Index of change proposals

## All Sections

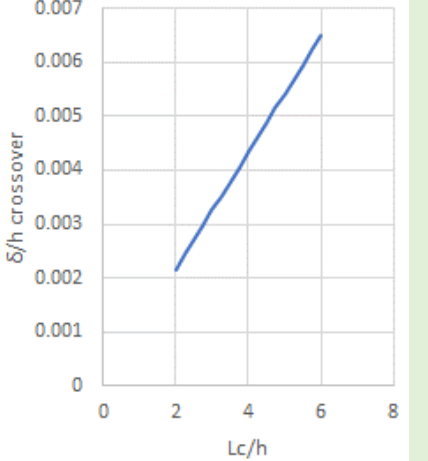
C5-78a	C5.6.3.6	Parts (b) and (c) of figure above heading for Section C5.6.4 are not referred to, and potentially confuse users.	<p>Delete parts (b) and (c)</p> <p>Remove (a) sub-caption</p> <p>Change caption to <i>Plan on a part floor showing location of cracks and areas where shear can be transferred to perimeter frames</i></p> <p>Change references to just point to Figure 5.40 – i.e. no (a)</p>	Editorial clarification
C5-78b	C5.6.4	Section does not provide guidance on rotation capacity of panel connections.	Edit note to link back to new content added in Section C5.5.3.3 (Change C5-42a)	Editorial
